Application Serial No. 10/625,287
Reply to Office Action of November 28, 2005

PATENT
Docket: CU-3301

Amendments To The Drawings

REMARKS/ARGUMENTS

FIG.3 BEST AVAILABLE COPY

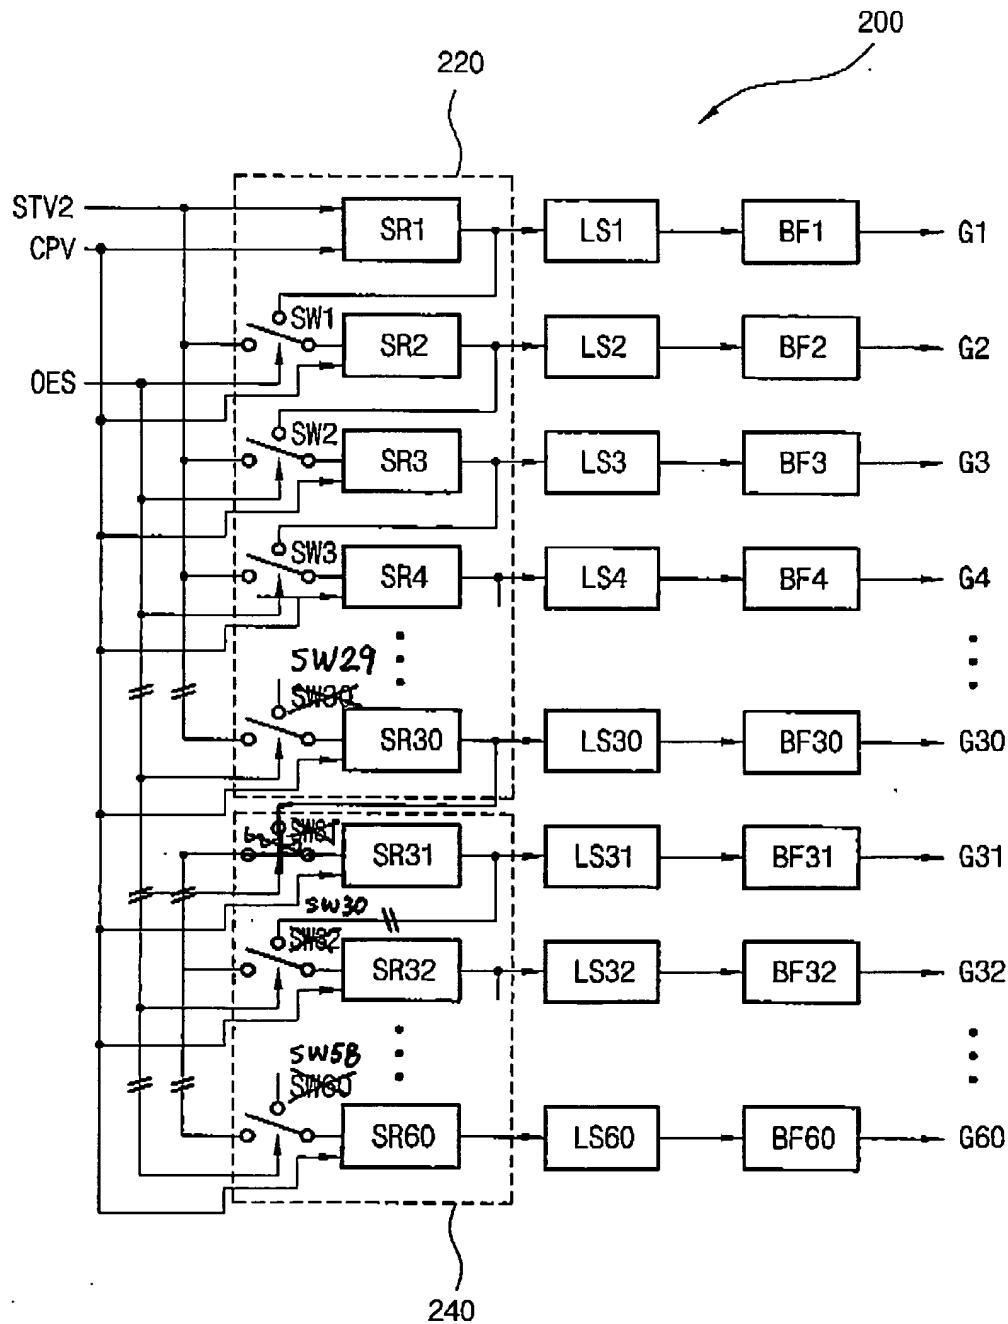
The attached sheets of drawings implement changes to FIGS. 3-9.

Annotated Sheets Showing Changes to FIGS. 3 and 6.

In the office action, the Examiner objected to FIGS. 3, 4 and 6 of the above-identified application as having various informalities identified on page 2 of the Office Action. In response, FIGS. 3-4 and 6 have been appropriately amended according to the disclosure of the present invention without adding new matter. Withdrawal of the objection is respectfully requested.
